160 Whitehorse Road, Blackburn

Planning & Urban Design Evidence

Prepared for the City of Whitehorse by Message Consultants, June 2019

Figure 4. Street tree planting in 'deep soil zone' from MDG landscape plans

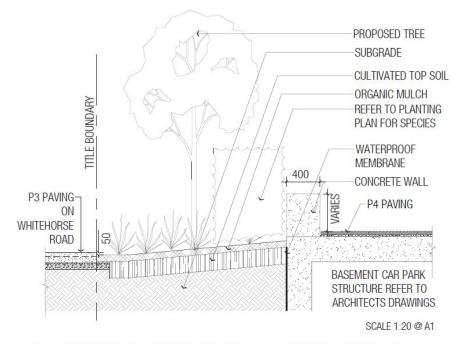
these reach the estimated mature height of 12m they will complement the existing Eucalypts along Whitehorse Road and ensure the proposal is in keeping with the leafy character of Blackburn. Guaranteeing the feasibility of street tree plantings is critical and the landscape plans prepared by MDG consider this, as shown in Figure 4 below. Street trees planted adjacent to the basement structure must be able to reach the height of nearby street trees and provide a pedestrian friendly scale to the street wall of the proposed buildings.

- Ensure that proposed landscaping treatments, in particular the proposed street tree
 plantings, are able to reach the maturity indicated in the landscape plan and form part of
 the broader landscape character of the area.

Figure 5. Examples of concrete textures in precast elements

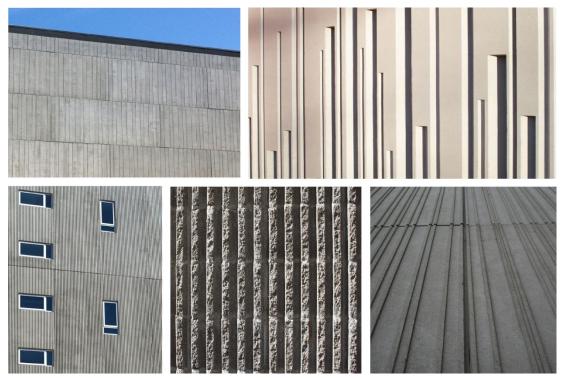
The separation between office building A and residential building C can be seen on the south elevation as a full height, blank concrete walk. This wall functions as a buffer between the office use and residential use and limits overlooking into west facing bedrooms and balconies. This is an undesirable outcome, both as an outlook for west-facing apartments and from the Railway Road aspect. One of two solutions could be employed. Firstly, the wall could be patterned or textured in order create visual interest at a scale readable from street level. Figure 5 below shows some examples of this technique. Alternatively, south-facing highlight windows could be introduced to the office area, to reduce the visual dominance of the concrete wall while avoiding overlooking into adjacent apartments.

- Request a specification of concrete texturing to be used for the large walls proposed on the south and west elevations of Building A.
- Request a large scale urban art work for the concrete boundary wall on the west elevation of Building A in place of the proposed outdoor advertising sign. Specify that the work should reference the landscape character of wider Blackburn.
